Index 676-010 Cabinet Installation Details

COMMENTARY

COMMENTS AND RESPONSES

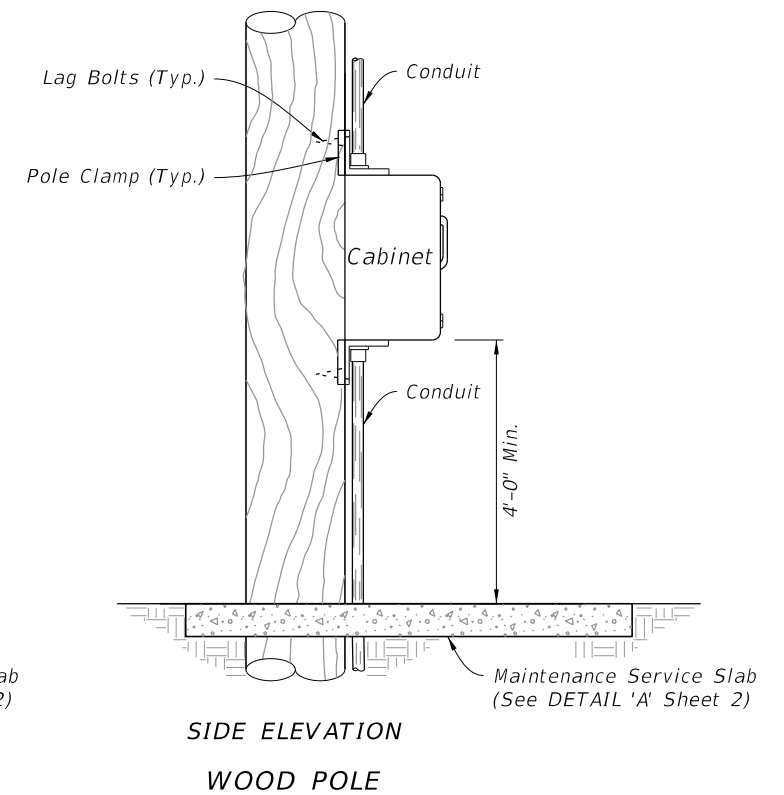
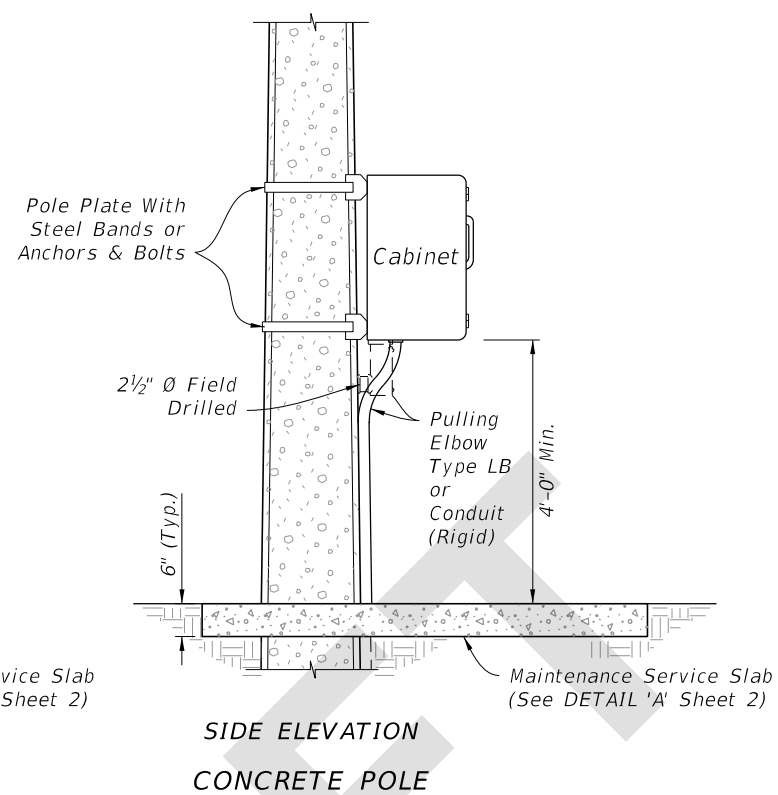
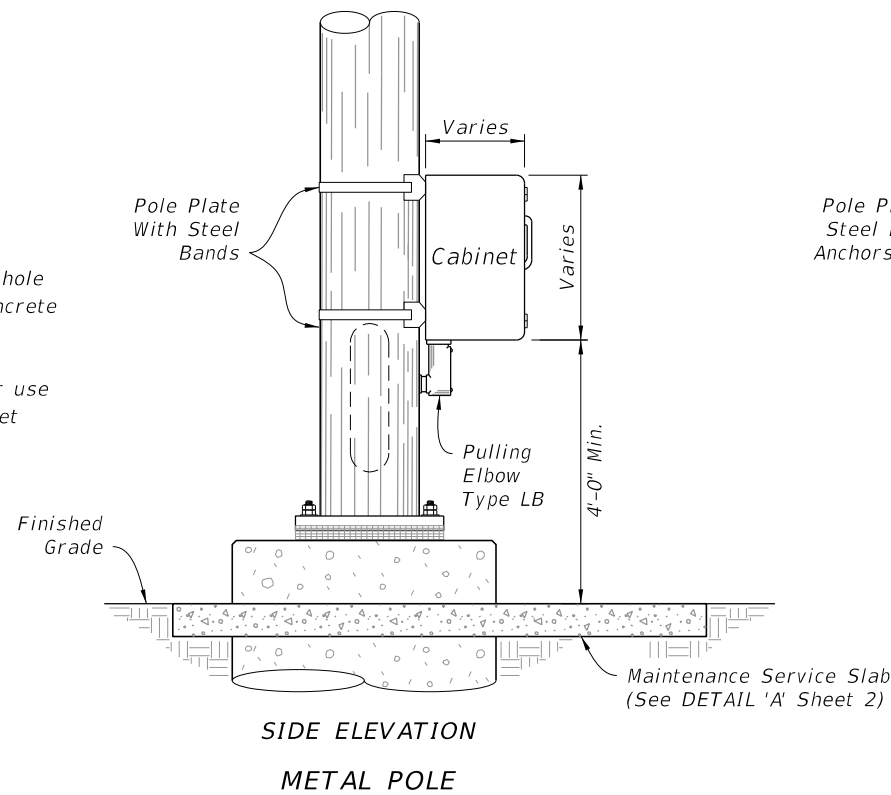
COMMENT: On sheet 6 of 6, maybe the location of the proposed maintenance slab can be shown to be cast against the shaft as opposed to being cast against the conduits. Also, will the Department consider making the maintenance slab of a standard thickness or will it need to be designed by a structural engineer.

RESPONSE: Agree the slab should be shown to be cast against the shaft and the conduits should be adjusted. The maintenance slab is intended to be 6" thick. This is shown in Index 676-010 and Index 676-010 is referenced in this Index. We will revise 641-020, 649-020 and 676-010 to show the slab thicknesses accurately.

CHANGE TO THE INDEX: Edit slab adjacent to shaft and adjust conduit. Edit pull boxes throughout the index to show 6" aprons to match maintenance service slabs.
